**Clarification Log – last updated 13 March 2025**

Fig 1.

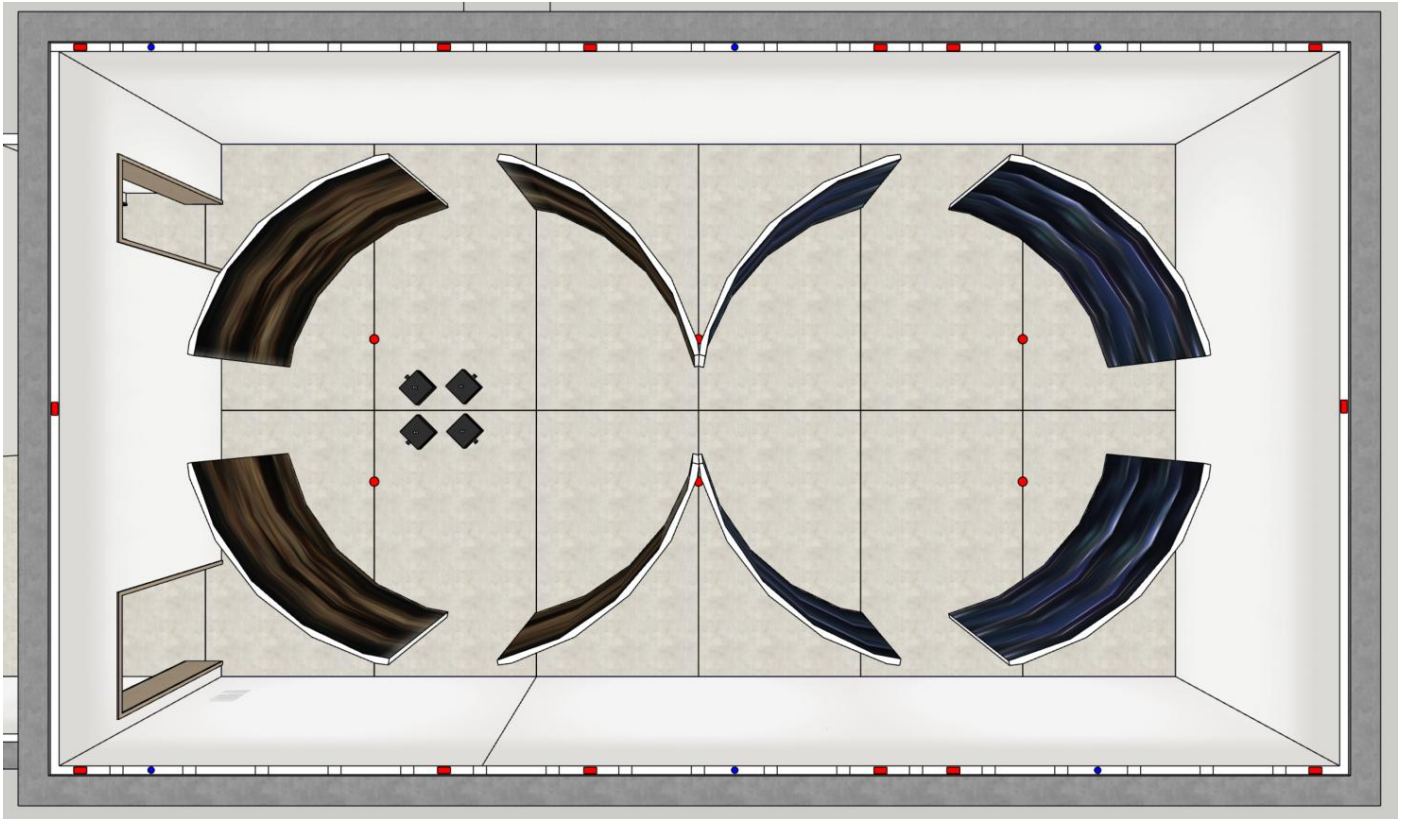
Q No	QUESTION	ANSWER	STATUS
3.	Where and how will we be able to run power and data cable runs in the space?	<p>Cable runs should be planned for around the ceiling as we expect the projectors to be mounted from the ceiling.</p> <p>Power outlets – Check fig. 1. 6x 3 pin commando sockets at the top of the walls (marked as blue circles). 14x double standard sockets at the top of the walls (marked as red rectangles). standard UK power outlets. 6x quad standard sockets in the floor (marked as red circles).</p>	Response Issued 05.03.25

36.	Please clarify the specification and location of any available power.	Please refer to Fig 1. below: <ul style="list-style-type: none"> <li>• Red rectangles are dual 240V sockets at the top of gallery walls, height 533cm</li> <li>• Blue circles are commando sockets at the top of gallery wall, height 533cm</li> <li>• Red circles are sets of 4x sunken floor sockets.</li> </ul>	Answered 13/03
